Safety from falling in an entertainment centre

1 THE MATTER TO BE DETERMINED

- 1.1 The matter before the Authority was whether a safety barrier in an entertainment centre complied with clause F4 of the building code.
- 1.2 In making its determination, the Authority has not considered any other provisions of the building code.

Figure A

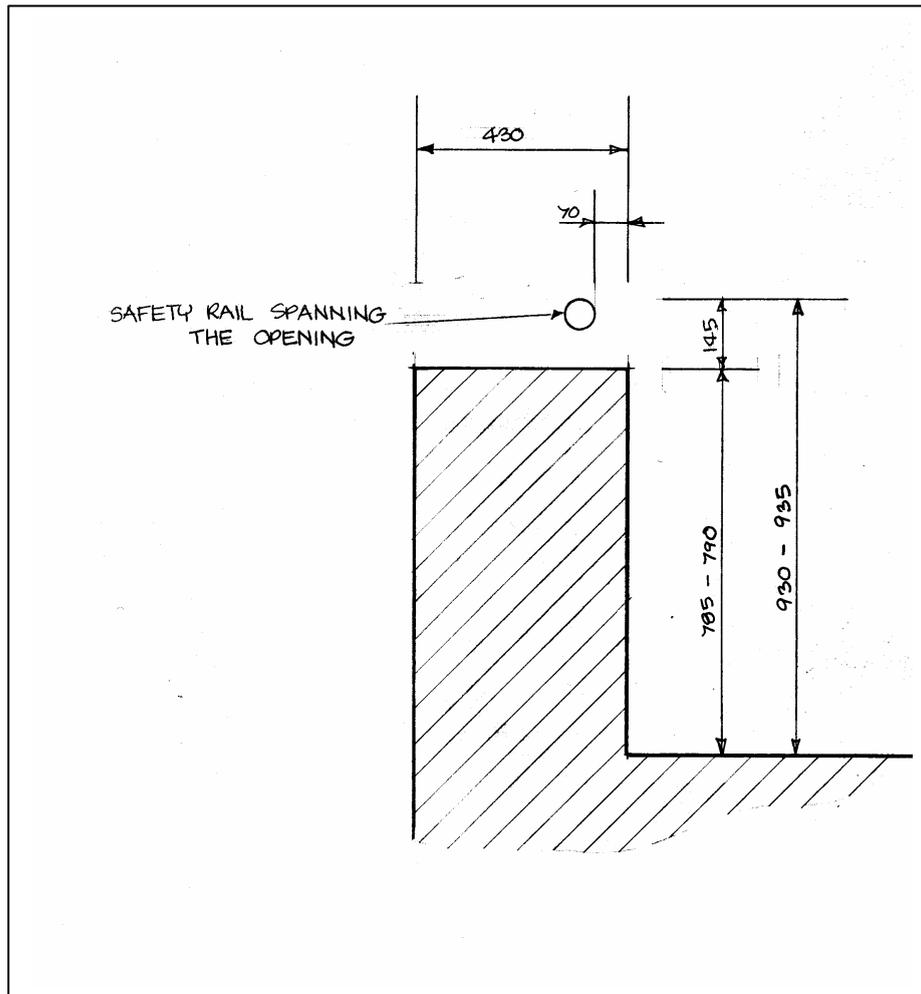
- 3.3 Immediately after the accident, the barrier was altered by raising the safety rail and infilling the gap between the rail and the wall below it. The Authority received conflicting information as to the dimensions of the barrier at the time of the accident, but this determination is made on the basis of the dimensions shown in Figure A on the next page (see also 5.1.4 below).

- 5.1.3 That information was accordingly copied to the parties.
- 5.1.4 To resolve the conflicting evidence as to the dimensions of the barrier, the Authority commissioned a consultant to visit the building and measure the barrier. Figure A above is based on the consulting engineer's report. It shows dimensions significantly different from those shown in the sketch forwarded by the Member of Parliament and slightly different from those shown in the OSH report. In particular, Figure A shows the height from floor level to the top of the inside edge of the wall as varying from 785 to 790 mm along the length concerned, whereas the drawing in the OSH report shows the top of the wall as having a height from floor level of 780 mm.

6.6.1 The dimensions of the barrier as measured by a consulting engineer engaged by the Authority are shown in Figure A on page 2 above. The ledge varied in height along its length from 785 to 790 mm. This determination is based on the minimum height of 785 mm from finished floor level to the top of the ledge and 930 mm to the top of the safety rail.

6.8.3 The only feature of the barrier that might be seen as compensating for the lack of height was the 430 mm width of the ledge located 145 mm below the top of the safety rail. The question is whether that would enable a person toppling over the barrier to save themselves by putting a hand on the ledge.

- 6.8.8 The Authority cannot see any reason why the addition of the safety rail in the position indicated in Figure A should have made the barrier any less effective. On the contrary, anyone whose centre of gravity was higher than 785 mm could pivot on the edge of the ledge and start to fall over the barrier, but if their centre of gravity was lower than 930 mm they would be saved by the safety rail (ignoring momentum effects). The Authority does not consider that the safety rail would obstruct hand movement so as to prevent people whose centres of gravity were between 930 and 1000 mm from saving themselves by putting their hands on the ledge.

- 7.1 In accordance with section 20(a) of the Building Act, the Authority hereby determines that the barrier complied with clause F4 of the building code and confirms the territorial authority's decision to issue the code compliance certificate.

Figure 1: Barriers to balconies

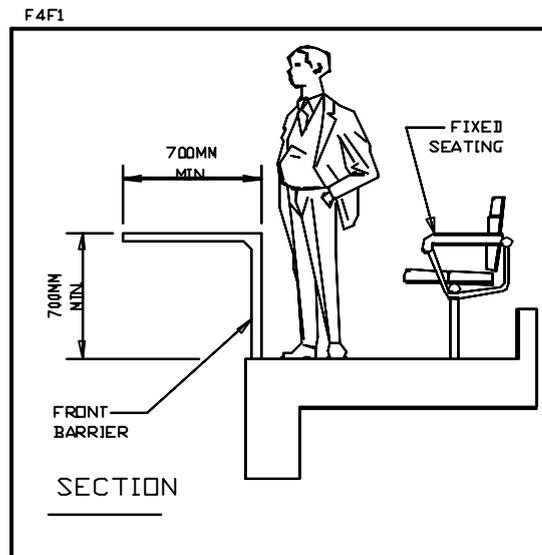
- (b) “F4/AS1, Figure 1: Barriers for balconies in front of fixed seating, shows for a barrier height of 700 mm, a horizontal width at the top of the barrier of 700 mm. The . . . ledge was 61% of this width. For a person facing the barrier and able to put out a hand this could have assisted in arresting a fall. For a person with their back to the barrier the ledge would have to arrest the falling trunk.”

6.7.2.1 The barrier was clearly not in the type of situation contemplated by Figure 1 of F4/AS1 reproduced on page 3 above. Furthermore, the barrier differed from Figure 1 not only in that it was higher but narrower but also in that the ledge was not the top of the barrier. The Authority accordingly considers that the barrier did not comply with paragraph 1.2.4 of F4/AS1.
